Number	0.1
Section	Heating and Windscreen Washing Equipment
Sheet	1 (of 1)
Date	January, 1960

### WINDSCREEN WASHING EQUIPMENT - FROST PRECAUTIONS

Number 0.2  
 Section Heating and Windscreen  
 Washing Equipment  
 Sheet 1 (of 1)  
 Date July, 1960

Number 0.3  
Section Heating and Windscreen  
Washing Equipment  
Sheet 1 (of 1)  
Date November, 1960

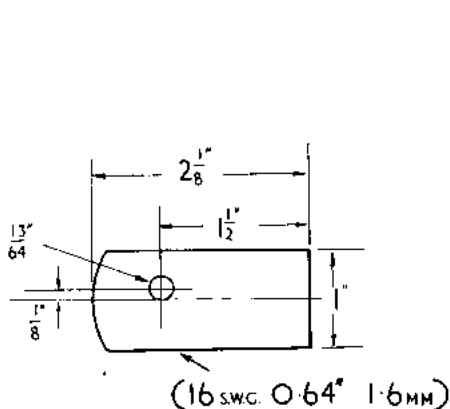
Contrary to instructions contained on page 22 of the Mark 2 handbooks it has been found that emptying the water from the container may not protect the unit from frost damage as a certain amount of water may be retained in the pump unit.

It is, therefore, recommended that two measures of denatured alcohol (methylated spirits) is added per container of water; the underside of the rubber filler cover will be found to form a measure. Do NOT use any additive other than that recommended as this will be detrimental to the equipment.

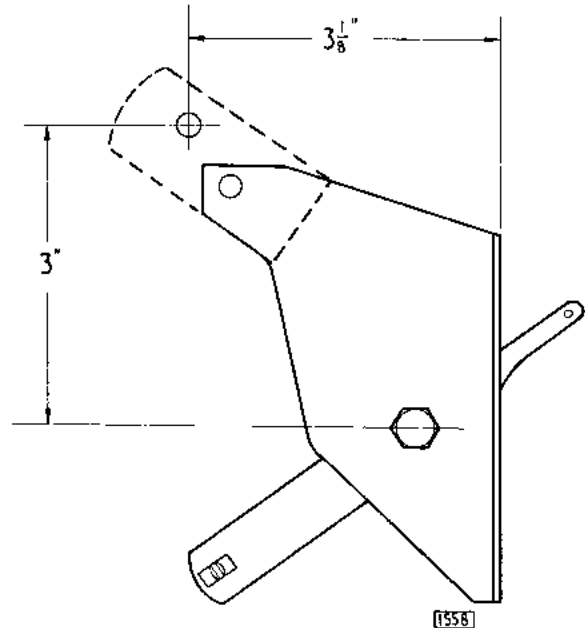
If complaints are received of insufficient heating and demisters blowing cold when the control is in the HOT position, carry out the following rectification procedure:-

- (1) Place the control in the "Hot" position.
- (2) Check the uppermost of the two levers on the engine side of the heater box for further travel. (Note: a small amount of extra travel due to compression of the foam rubber sealing strip is normal).
- (3) If extra travel exists this indicates that the heater flap is not closing fully and it will be necessary to carry out the following modification.
- (4) Remove the casing from the left-hand side of the heater panel by unscrewing the two knurled nuts. Detach the Hot-Cold knob by unscrewing the screw in the side of the knob. Remove the two nuts at the rear of the operating lever bracket and detach the bracket. Disconnect the cable and remove the outer cable clip.

- (5) Make up an extension strip from 16 S.W.G. (.064" - 1.6 mm) steel and weld or bolt it to the control lever bracket in the position shown.
- (6) Refit the outer cable clip to the hole in the extension strip.
- (7) Reconnect the cable and refit the bracket.
- (8) Re-check operation as described in paragraphs 1 and 2.

INS.	MM.
$3\frac{1}{8}$	79.4
3	76.2
$2\frac{1}{8}$	54.0
$1\frac{1}{2}$	38.1

INS.	MM.
1	25.4
$\frac{13}{64}$	5.16
$\frac{1}{8}$	3.2
